Lean Condition Between 2000 and 3500 RPM - 135 Thru 200

Mariner and Mercury

1990 thru 1992

S/N 0C221500 thru 0D181999

Figure 1. Jet Location

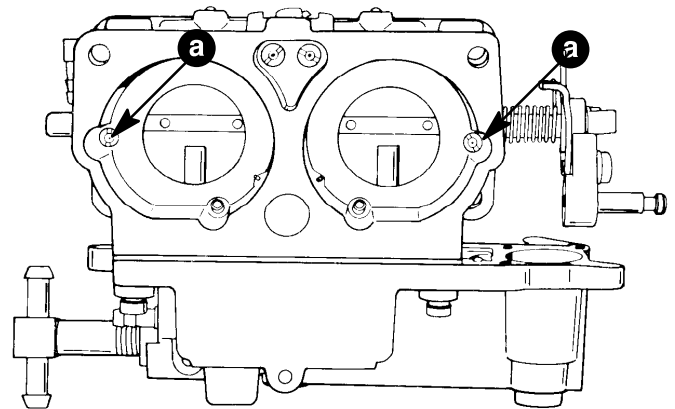
ENGINE GRADUALLY LOSING ENGINE SPEED AND EVENTUALLY QUILTS RUNNING may be caused by incorrect progression air jets. Only 1991 and 1992 carburetors listed below are suspect to the lean condition that causes the engine to loose RPM and eventually quit.

Correct the lean condition by change the existing progression air jet in all three carburetors from 0.070 to 0.048 inch. Part number of the 0.048 jet with 8-32 thread is 815633048. Six (6) jets are required per engine.

Figure 2. Attenuator

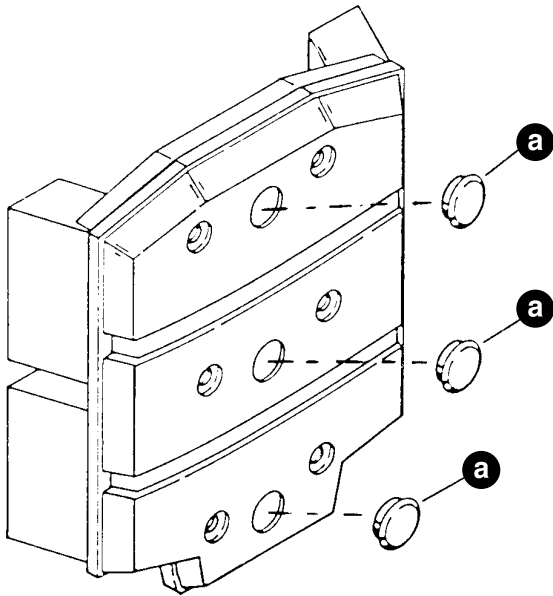
ENGINE LEAN SURGING may be caused by increased vacuum created in the air box.

REMOVE THE THREE PLUGS IN THE FRONT OF THE ATTENUATOR.

Figure 3. WMH Carburetor

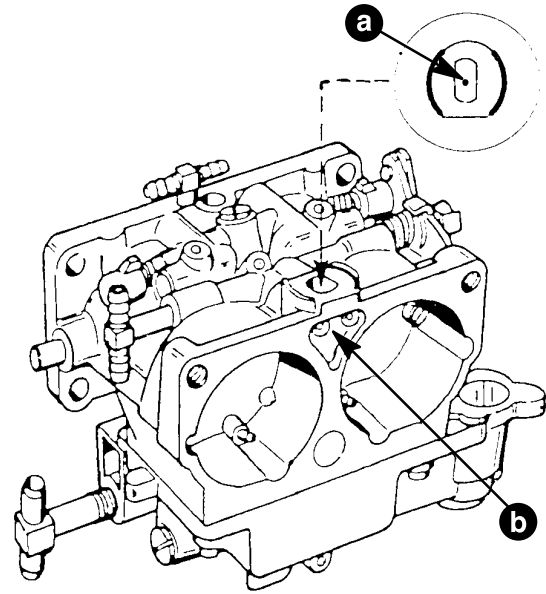
DRILL THE IDLE AIR/BACK DRAG CAVITY.

Drill a 9/64 inch (3.57 mm) hole in the center of the upper carburetor casting pocket to the idle air/back drag jet cavity on each carburetor.

IMPORTANT: Remove any drilled material from the idle air/back draft jet cavity.

Reinstall carburetors, sound attenuator and synchronize carburetors. Carburetors installed on 1993 outboards (s/n 0D182000 and above) have the hole drilled.
